## **ALERT SERVICE BULLETIN**

**212-24-169**

**MODEL AFFECTED:** 212

**SUBJECT:** INSPECTION OF CAP ANGLE, P/N 212-030-191-001, INTRODUCTION, OF.

**Figure1. Fuselage Tailboom Attachment Inspection.**

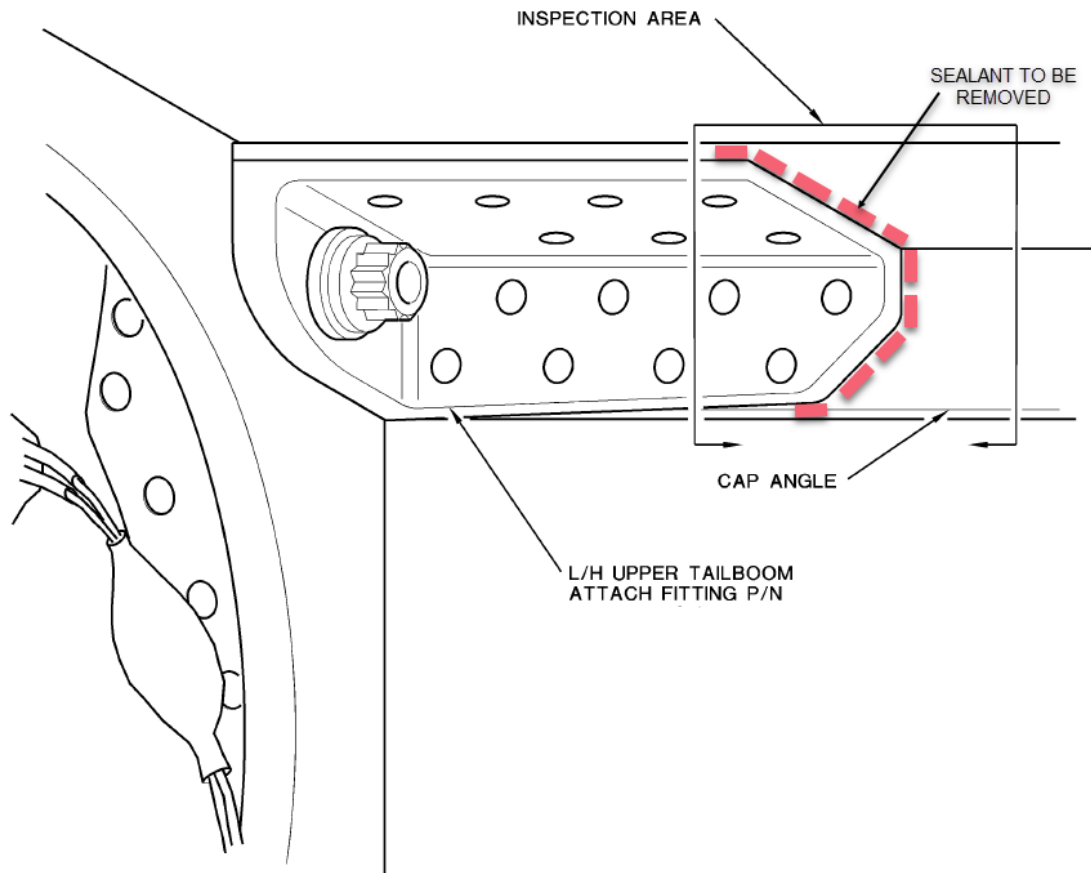
2. If sealant is present, remove sealant from edge of fitting (Figure 1).
3. Inspect the cap angle area shown with a 10x magnifying glass and bright light.
4. If a crack is found, replace the cap angle before further flight. If the helicopter is at a location where the cap angle cannot be replaced, contact Product Support Engineering.
5. Touch up primer if damaged during sealant removal. Paint touch up is optional. Do not reapply sealant.
6. If no cracks are found, the helicopter can be returned to service.
7. Make an entry in the helicopter logbook and historical service records indicating findings and compliance with this Alert Service Bulletin.
